## ULAN WEST MODIFICATION

Response To Submissions

August 2015

Prepared by  
**Umwelt (Australia) Pty Limited**

FIGURE 2.1

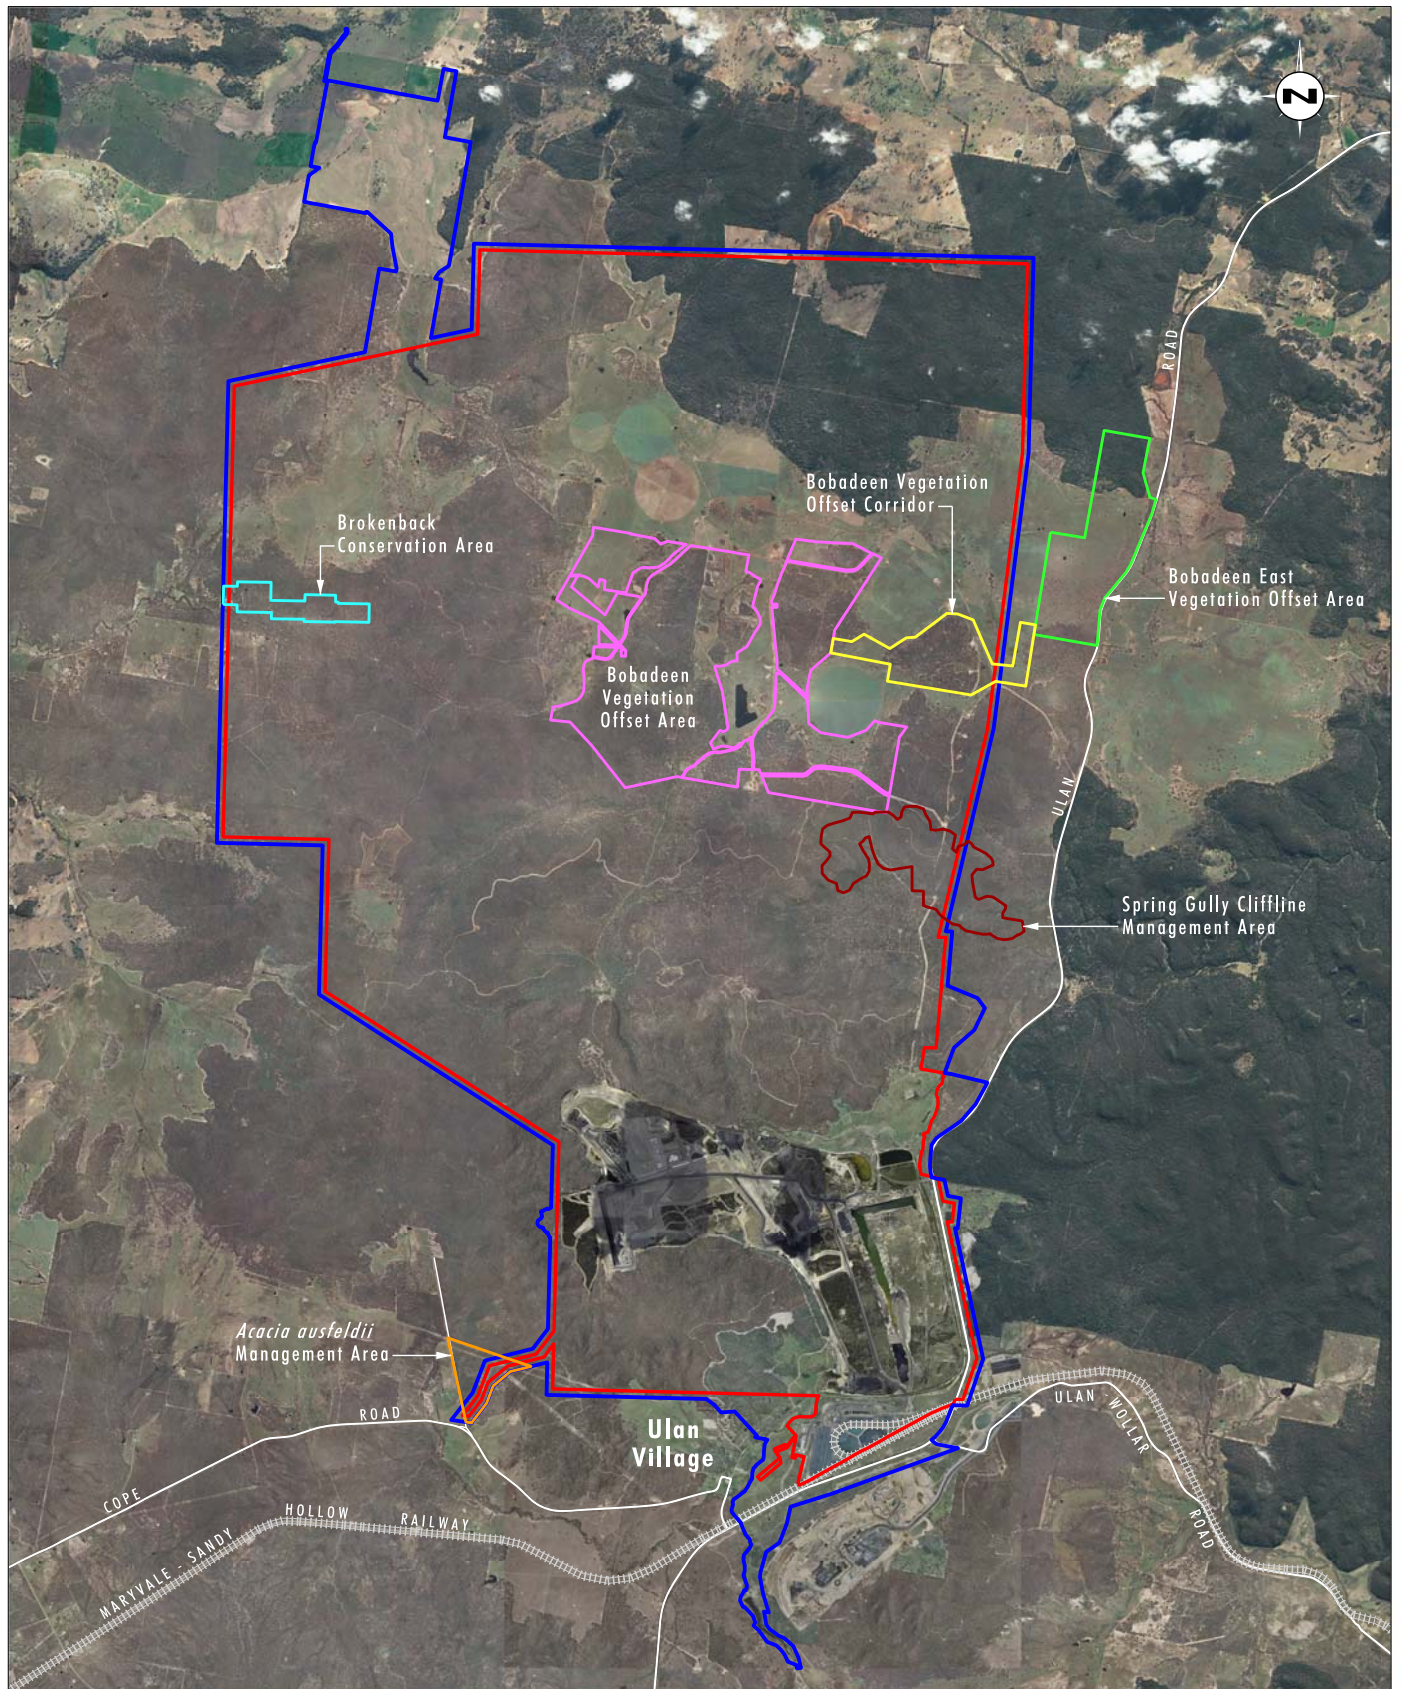
**4.2 That detail is provided regarding the Highett Road Ausfeld's wattle population. This should include a map at an appropriate scale depicting the areal extent of the population, the status of the offset security, and the management actions that have been implemented.**

### **5.2 That detail regarding the Spring Gully Cliffline offset area be provided as per recommendation 3.1.**

The location of the *Acacia ausfeldii* adjacent to Highett Road is provided on **Figure 2.1**. The management and monitoring commitments are summarised below and detailed in the BMP and OMP.

A summary of the Spring Gully Cliff Line Management Area is outlined above and details are provided in the BMP and OMP which were developed in consultation with OEH to the satisfaction of DP&E. The location of the Spring Gully Cliff Line Management Area is shown on **Figure 2.1**.

FIGURE 2.2

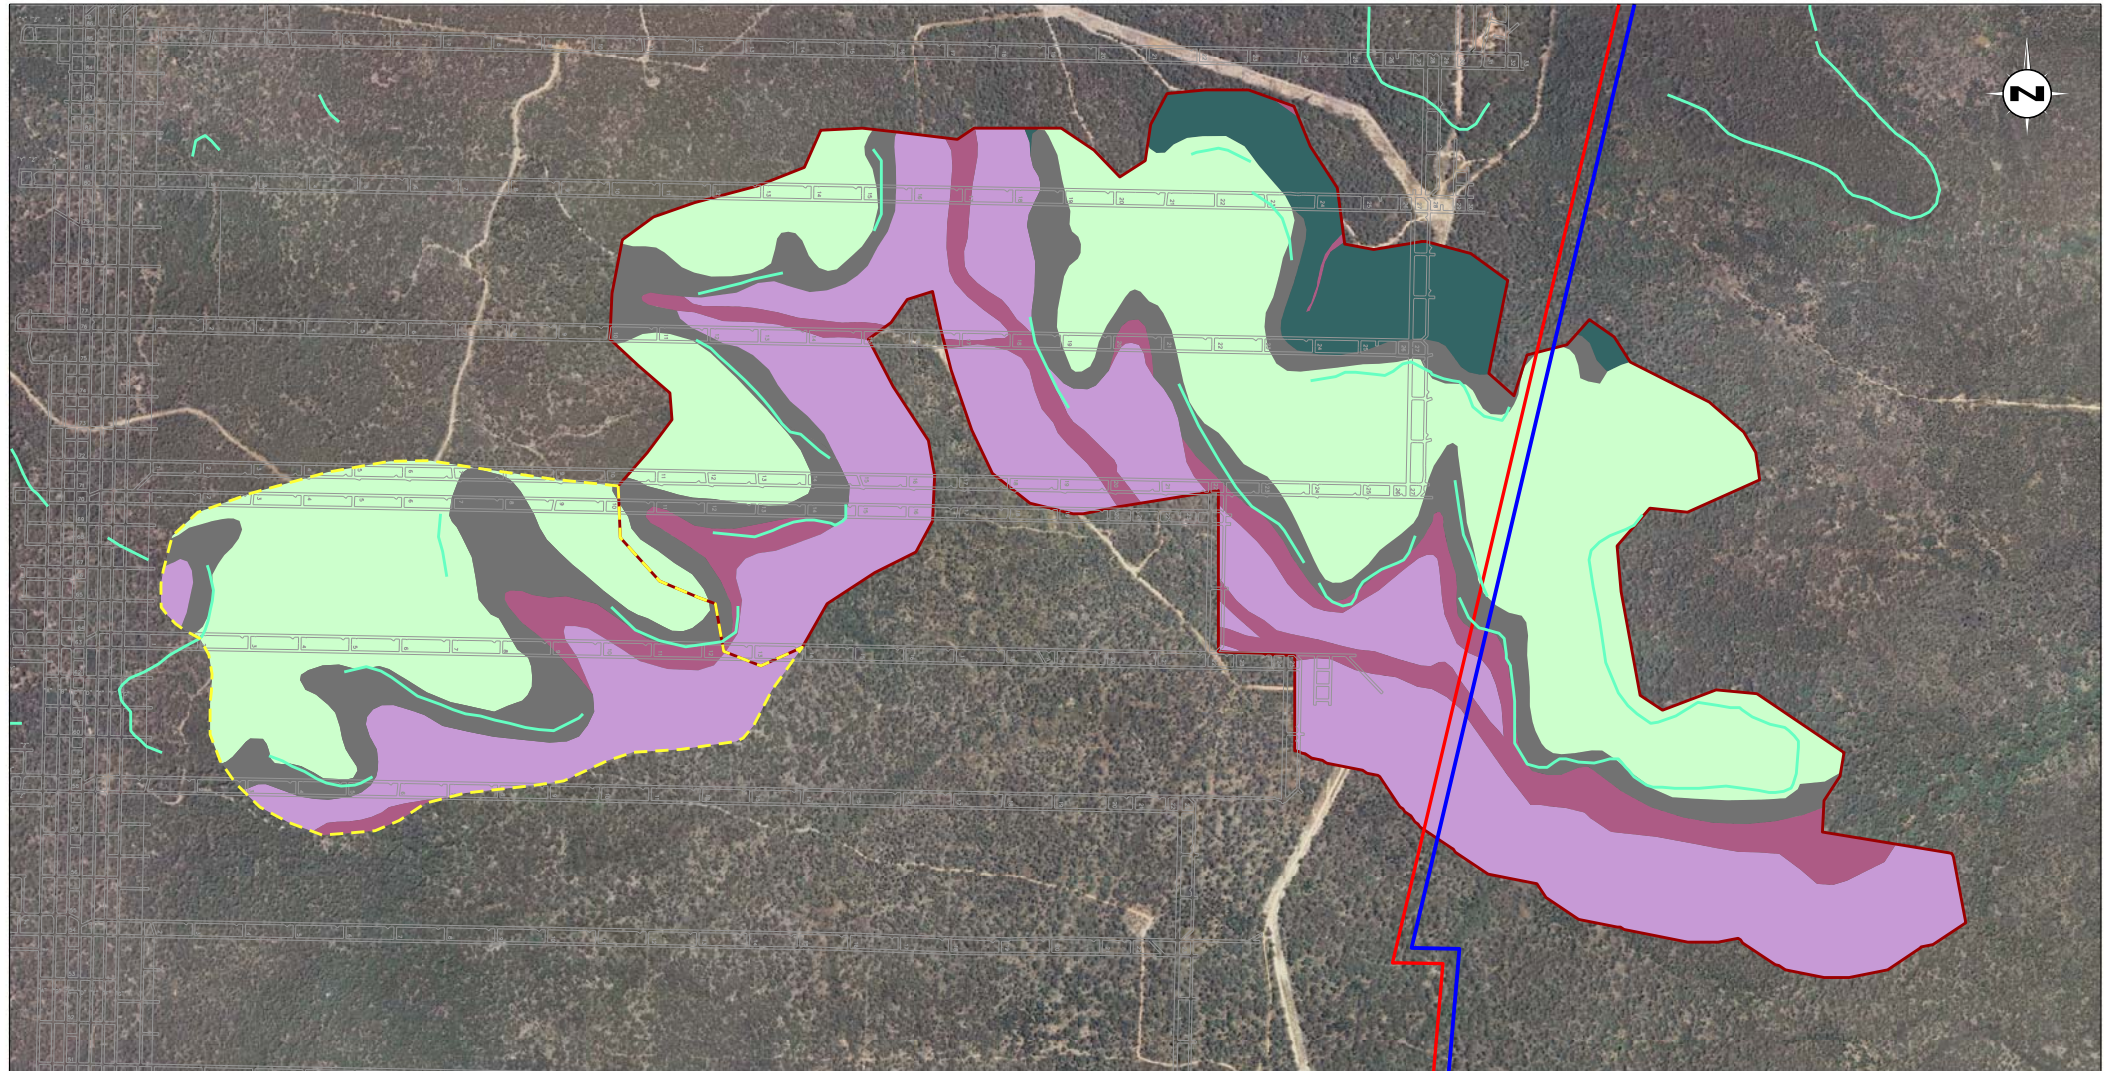
**While OEH concurs with the extension of the monitoring program, we are concerned that, despite the doubling of the area of predicted cliff line impact and the assumption that this area may be used by micro bats, the Ecological Assessment and EA do not provide any options for avoidance and/or mitigation measures to reduce the potential for cliff fall. The assessments also do not provide a review of offset requirements or any information regarding the objectives, security and management of the Spring Gully Cliffline offset area.**

As described in **Section 2.3.3**, UCML propose an addition to the existing Spring Gully Cliff Line Management Area in order to compensate for the net increase in potential impact to the modelled cliff lines as a result of the proposed modification (refer to **Figure 2.2**).
